SLIDE-OUTS

NOTE: The pressure angle (PA) on all Lippert Through Frame slide-out gear packs has changed from 14.5PA to 20PA. This will require a change in replacement parts used for through frame slide-outs. See [TI-001](#) to determine the gear rack and spur gear currently in use.

Fig. 1

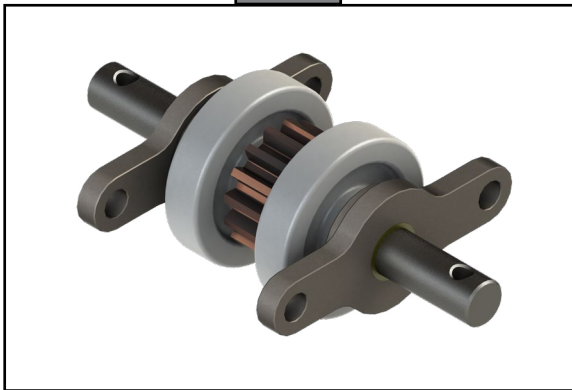
For customers with broken teeth in a gear pack, replacement parts will be a new gear pack (20PA) and an original spur gear (14.5PA). The pressure angle of the spur gear on the new gear pack will not mesh with the pressure angle of the old gear rack. The new gear pack will need to be disassembled, and the spur gear on the new gear pack will need to be replaced with the spur gear [122739](#).

1. Remove the roll pin (if equipped).
2. Remove the mounting plate.
3. Remove the spur gear.
4. Replace the spur gear with spur gear [122739](#).
5. Reverse the process.

Fig. 5.2

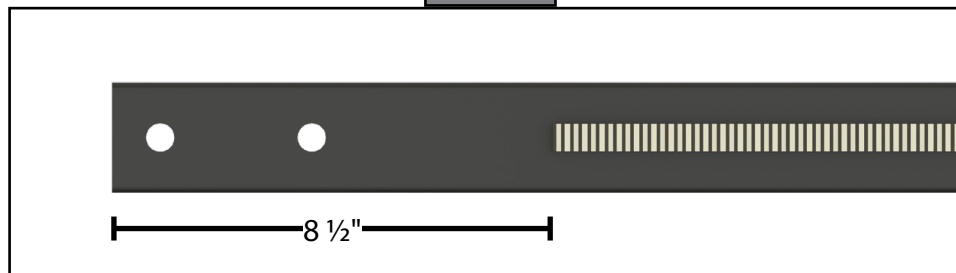
For customers with broken teeth in a gear rack, replacement parts will be two new inner arms, and two new gear packs. Both inner arms and gear packs **MUST** be replaced at the same time in order to maintain timing. The pressure angle of the spur gear on the new gear pack will not mesh with the pressure angle of the old gear rack.

- 2" x 2" Inboard (20PA) - **163778** (Fig. 5.1, Fig 5.2)
- 2" x 2" Outboard (20PA) - **145736** (Fig. 6.1, Fig 6.2)
- 2" x 2" Gear Pack Assembly (20PA) - **281331** (Fig. 1)
- 2 ½" x 2 ½" Inboard (20PA) - **143710** (Fig. 7.1, Fig 7.2)
- 2 ½" x 2 ½" Outboard (20PA) - **143707** (Fig. 8.1, Fig 8.2)
- 2 ½" x 2 ½" Gear Pack Assembly (20PA) - **324869** (Fig. 2)
- 2 ½" x 2 ½" Heavy Duty Steel Gear Pack Assembly (20PA) - **123356** (Fig. 3)
